Office Action Summary	Application No. 10/803,474	Applicant(s) CHENG, STAN	
	Examiner Philip Gabler	Art Unit 3637

DETAILED ACTION

Nicolai et al. '400 Figures 1, 3, and 7

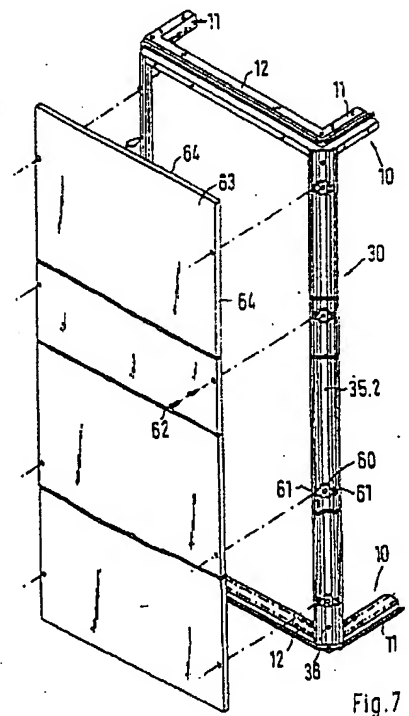
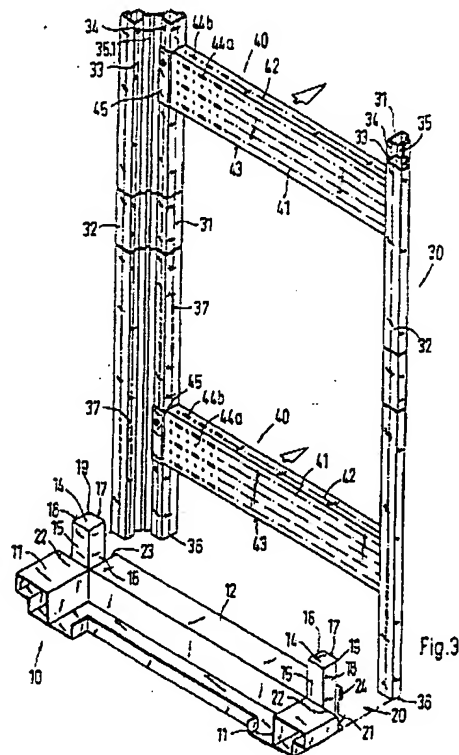
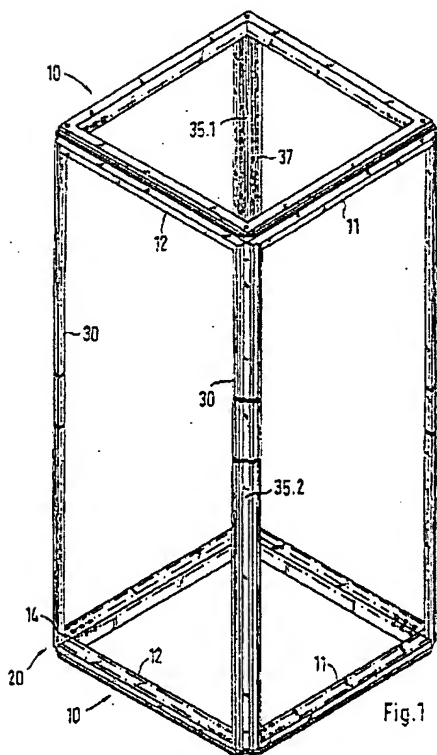
8. Claims 1, 2, 4-6, 9, 10, and 13 are rejected under 35 U.S.C. 102(b) as being anticipated by Nicolai et al. (US Patent Number 6123400).
9. Regarding claims 1, 2, 9, and 13, Nicolai (Figures 1, 3, and 7) discloses a chassis apparatus usable with a computer comprising: a chassis frame (10) comprising a set of load-bearing rails (30) located on edges of the frame; and a plurality of protrusions (box-like protrusions at sides of 30) formed on the load-bearing rails and adapted to support a chassis cover (63) for fitting over and secured to the chassis frame, and to laterally secure a removable structure (40) to the chassis frame in at least two directions by coupling the protrusions with portions (45) of the structure formed to be secured thereover, the removable structure configured to be capable of housing at least one small form factor computer component (see for example column 4 lines 65-67).

10. Regarding claim 4, Nicolai further discloses each protrusion has a flat top surface (viewed as the outer surface abutting the cover) to support the chassis cover.

11. Regarding claims 5 and 6, Nicolai further discloses protrusions which are mounted and integrally formed with the load-bearing rails of the chassis frame.

12. Regarding claim 10, Nicolai further discloses the portions of the structure comprise protrusions corresponding to the protrusions of the chassis frame.

Exhibit 1: Jeong '624 Figures 1 and 4C

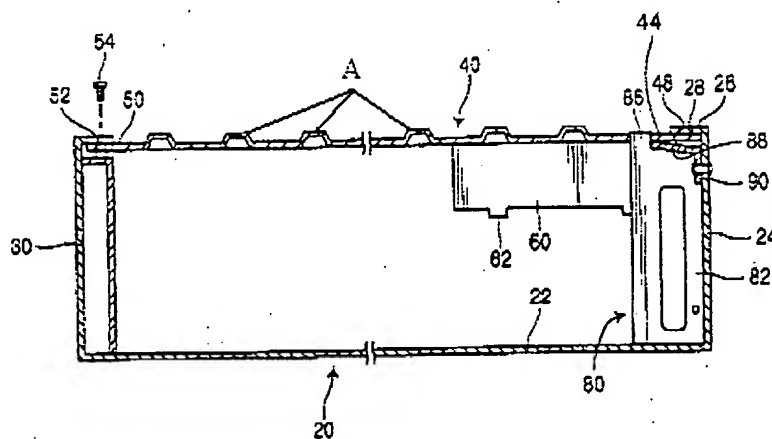
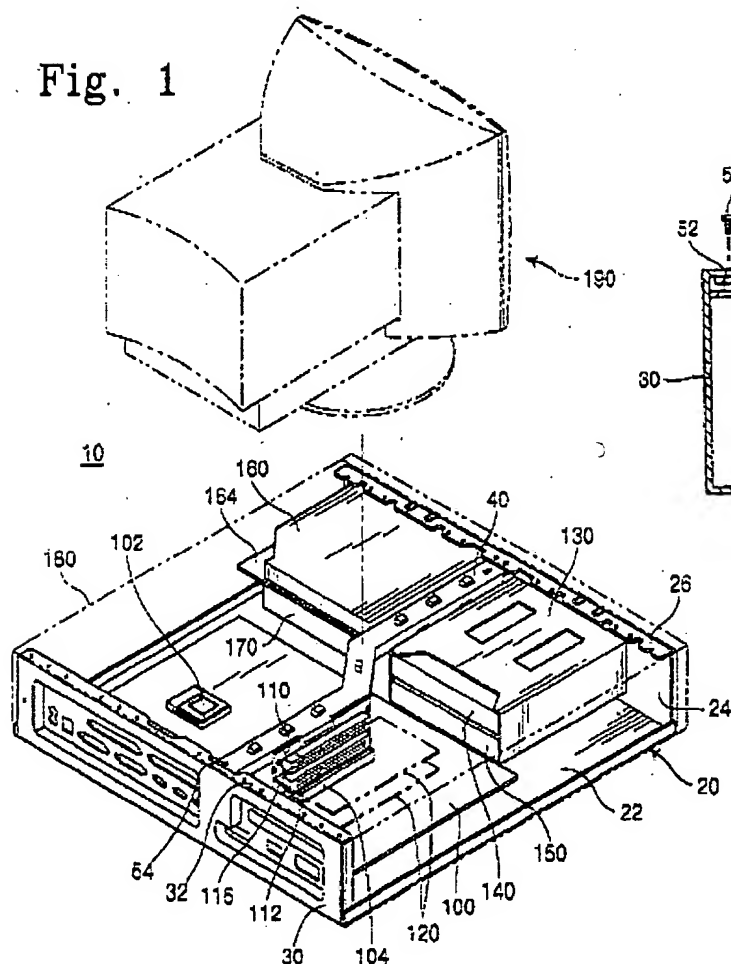
Chang's protrusions with Jeong's protrusions (i.e. domes which would engage the cover in place of hooks that do not) because this arrangement would provide additional strength and support to the chassis apparatus by better supporting the cover while still securing the removable structure (the holes of the removable structure would be fitted over and around the protrusions, laterally securing the structure in at least two directions).

Jeong discloses a computer chassis frame with domes (A) formed on an upward facing surface for supporting a chassis cover. Accordingly, it would have been obvious to one of ordinary skill in the art at the time the invention was made to modify Chang's oblong rounded structures to be domes as taught by Jeong because this arrangement would make installation and removal of the removable drive frame quicker and more simple (the frame could simply be placed on the upward facing surfaces with the interface structures fitting over the domes rather than sliding under hooks) as well as providing better support for the cover.

Chang '886 Figure 1

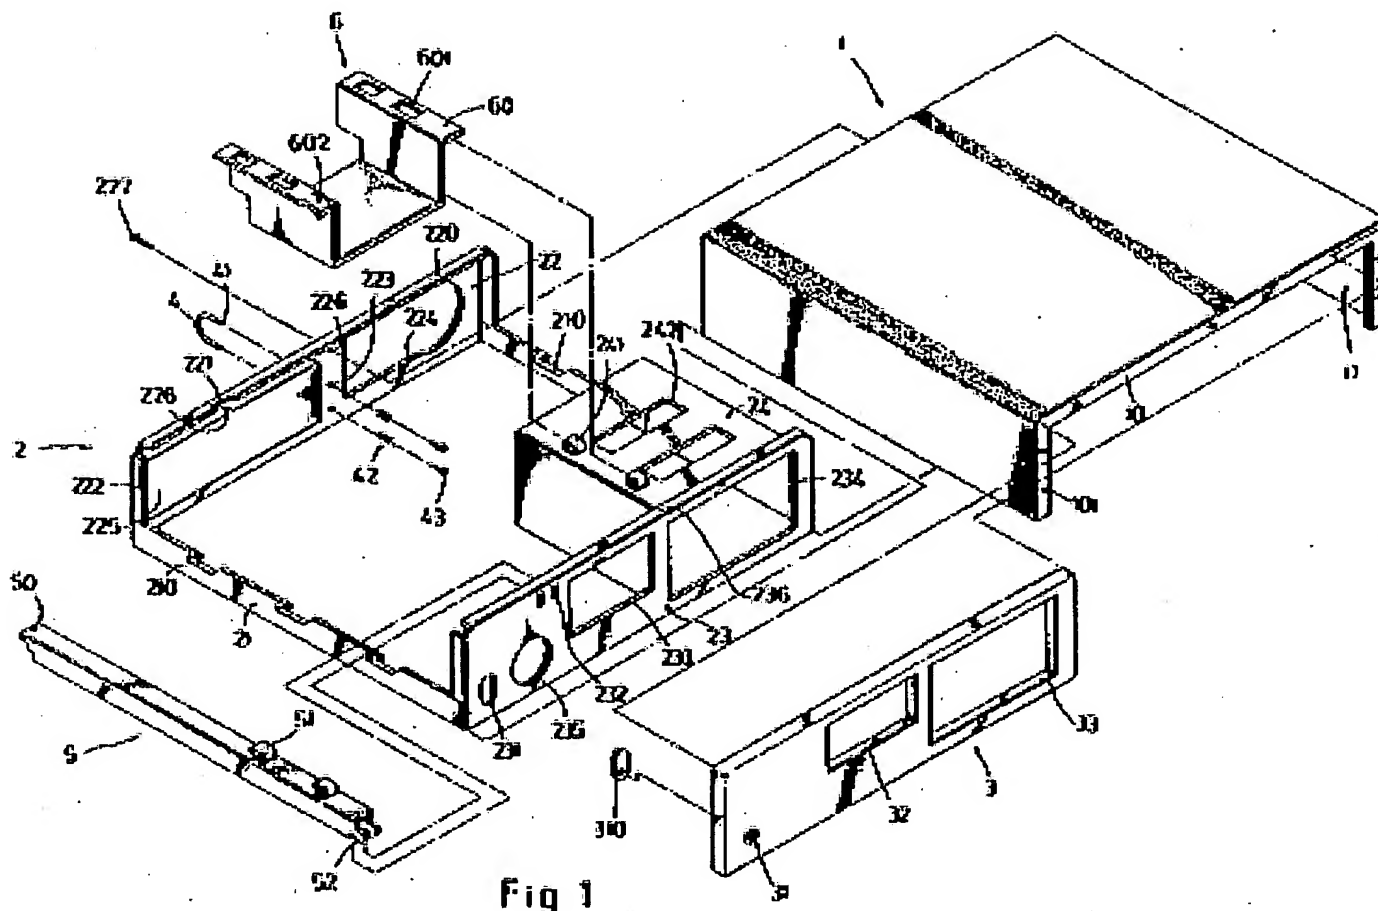
15. Regarding claims 1, 2, 9, and 13, Chang (Figure 1) discloses a chassis apparatus usable with a computer comprising: a chassis frame (2, including 5, 24, etc.) comprising a set of load-bearing rails (5, portions of 24) located on edges of the frame; and a plurality of protrusions (51, 241) formed on the load-bearing rails, and to laterally secure a removable structure (6) to the chassis frame by coupling the protrusions with portions (60) of the structure formed to be secured thereover, the removable structure configured to be capable of housing at least one small form factor computer component (element 6 is a drive holder). Chang does not disclose the protrusions as supporting a chassis cover (which is present as element 1). Jeong (Figures 1 and 4C) discloses a computer chassis apparatus including a load-bearing surface (upper surface of 40) including protrusions, or means for supporting a chassis cover, (viewed as A in Exhibit 1) configured to support a chassis cover (180). [See Figure 4C and column 4 lines 2-7 for disclosure of 40 (and protrusions A) acting as a support for the cover, monitor, etc.] Accordingly, it would have been obvious to one of ordinary skill in the art to replace

18. Regarding claim 10, Chang further discloses the portions of the structure comprise protrusions corresponding to the protrusions of the chassis frame (portions of protrusions 60 mate with the protrusions of the frame).

19. Regarding claim 14, Chang discloses a computer chassis apparatus comprising: a computer chassis frame (2, including 5, 24, etc.) for a form factor computer comprising at least two upward facing surfaces (upper surfaces of 5 and 24); a plurality of oblong rounded structures (51, 241) formed into the upward facing surfaces of the computer chassis frame and distributed along the surfaces; a removable drive frame (6) capable of supporting a plurality of drives of different sizes adapted to be installed within the computer chassis, the removable drive frame comprising interface structures (601) corresponding to each rounded structure. Chang does not disclose domes on the upward facing surfaces for supporting a chassis cover (the cover present as element 1).
